UNITED STATES PATENT AND TRADEMARK OFFICE

APPLICATION NO.	FILING DATE	FIRST NAMED INVENTOR	ATTORNEY DOCKET NO.	CONFIRMATION NO.
10/596,193	06/02/2006	Noriyuki Tajima	P30030	3321

DETAILED ACTION

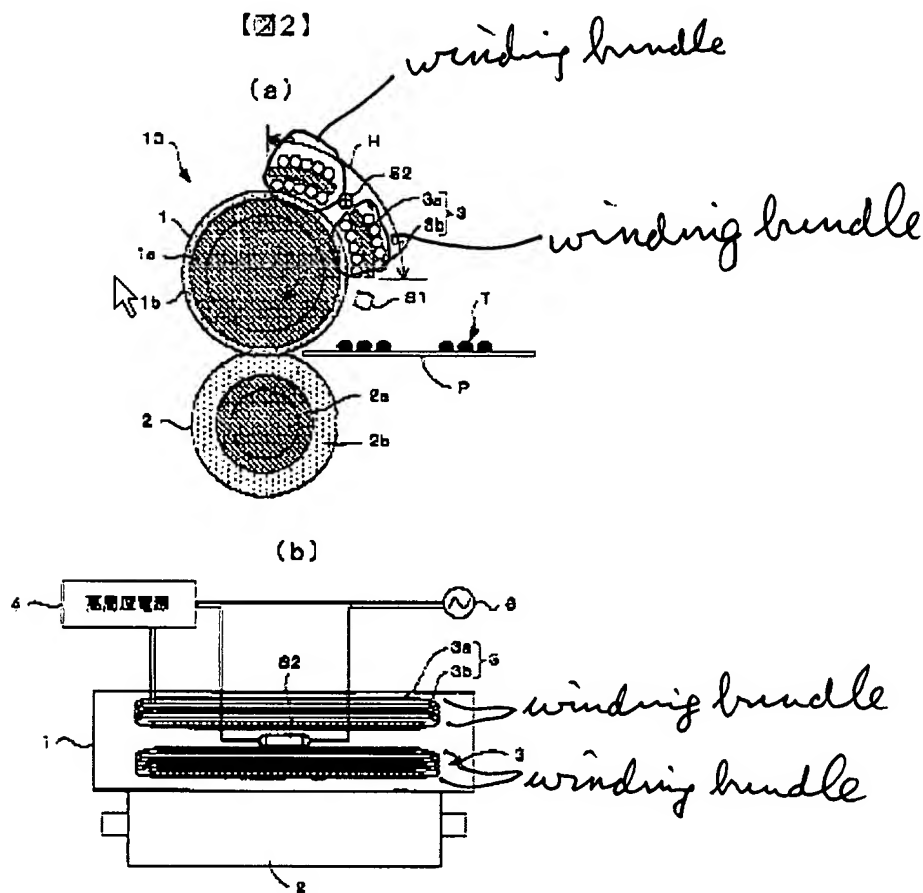
bundles of the conductor wire of said exciting coil (see Figures 1-10 and the English abstract). It is submitted that claimed limitation “temperature detection section is disposed on the same side as said exciting coil with respect to said heating element and between winding bundles of the conductor wire of said exciting coil” does not define over the location of S2 in Ricoh. For instance, as shown in Figures 2(a), 2(b), 5(a), 5(b) and 8, the temperature sensor S2 is clearly located between winding bundles of the coil 3 (see markings below).

There is no limitation that requires the temperature sensor be “disposed inside the coil windings”.
